Appendix 1:

Replacement pages of the Visual Appraisal

URA TO KWA WAN ROAD/ WING KWONG STREET DEVELOPMENT SCHEME (KC-016)

Visual Appraisal

Figure 2.2

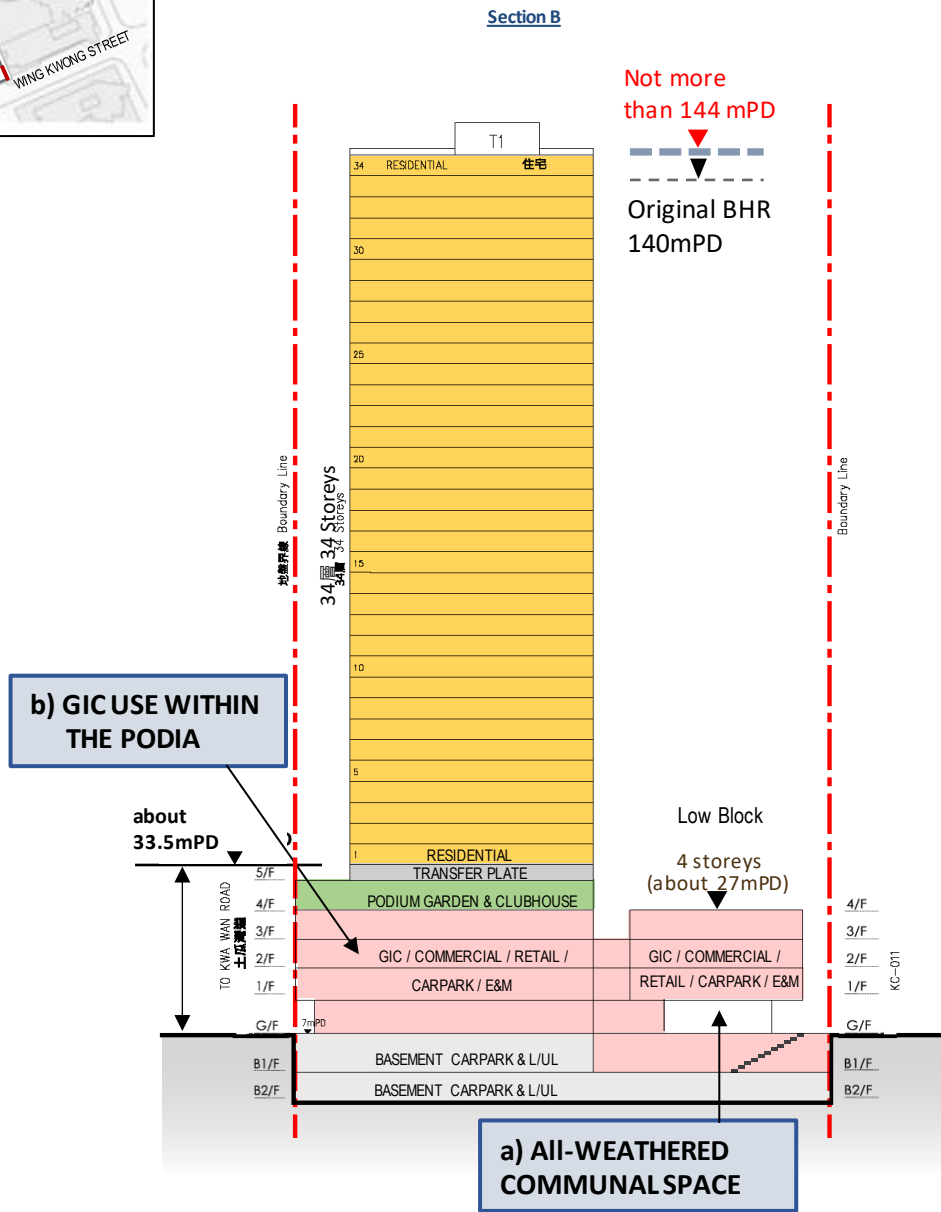
- 2.1. The subject S16 Planning Application seeks TPB permission for minor relaxation of BHR from 140mPD to 144mPD (+ about 2.9% (i.e. within 4% increase of total story height of MiC floors)) in accordance to JPN No. 8) to facilitate the adoption of MiC. The DPR and total PR under the Approved DSP will remain unchanged. The notional block plan and section plan are provided in **Figure 2.1** and **Figure 2.2** for illustration purpose and visual appraisal only.

PHOTOMONTAGES OF VP2 – Ma Tau Wai Road/ To Kwa Wan Road Garden
 URA TO KWA WAN ROAD/ WING KWONG STREET
 DEVELOPMENT SCHEME (KC-016)
Visual Appraisal

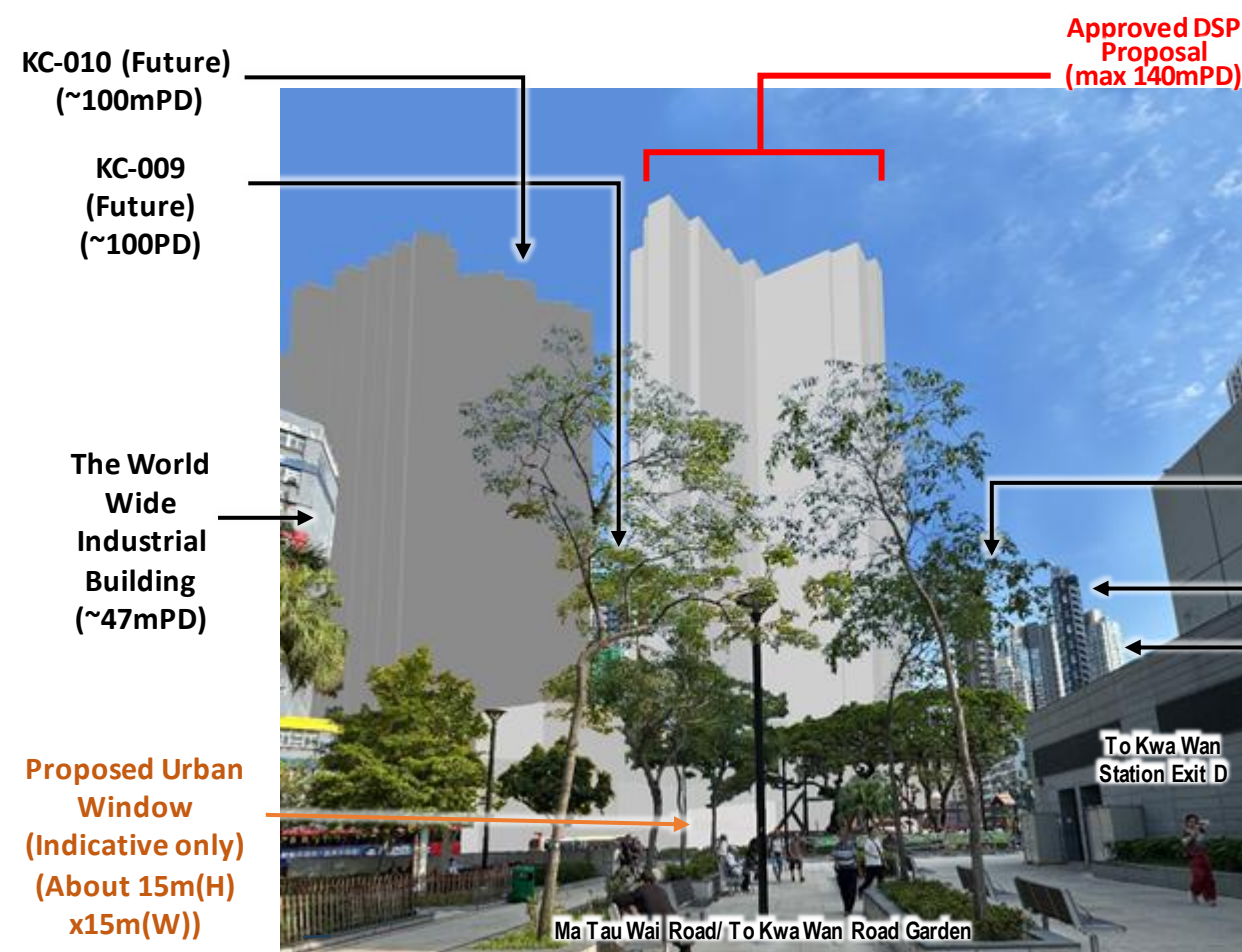
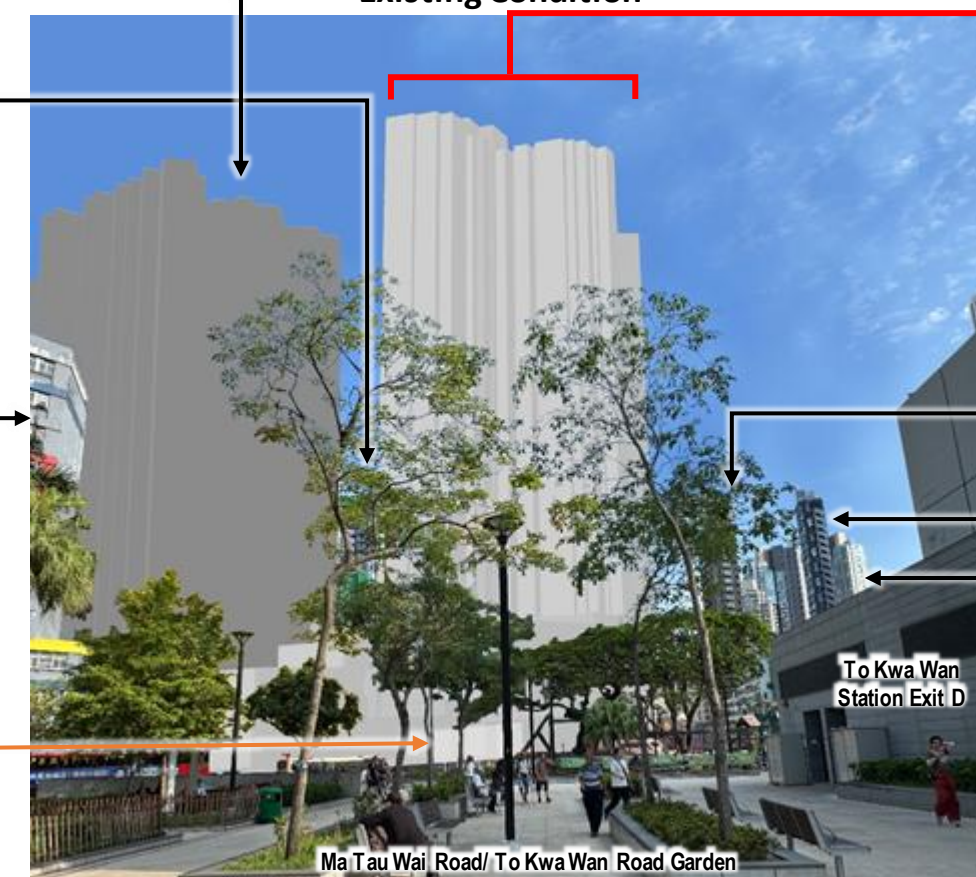
VP 2: Ma Tau Wai Road/ To Kwa Wan Road Garden	VSR: Facility users, nearby residents and pedestrians Type of User: Recreation/ Traveller	70m	As illustrated in Figure 5.2 , this VP consists of the high-rise developments including the URA KC-010 (~100mPD) in the foreground and Chatham Gate (~145mPD) in the background, with trees in the garden as visual buffer. It is anticipated that the slight increase in the BH at the Application Site will not affect the visual composition in this VP. The Current S.16 Proposal will reduce slightly a greater part of the sky view compared with the Approved DSP Proposal. However, the Notional Design of the Current S.16 Proposal maintains the good design features as mitigation measures including the urban windows at the podium (with a minimum dimension of not less than 15m in height and 15m in width, excluding architectural features, open-side deck and circulation) and the tower setback of 45m that helps maintain the separation between the proposed development and KC-010. These reduce the extent of obstruction to the sky view and maintain the visual permeability despite the proposed BH increase. The VSRs in this VP are either transient in nature travelling from/ to the MTR station or park users focusing on resting with occasional view towards the Application Site. Based on the above and considering the proximity of the Application Site,	Slight
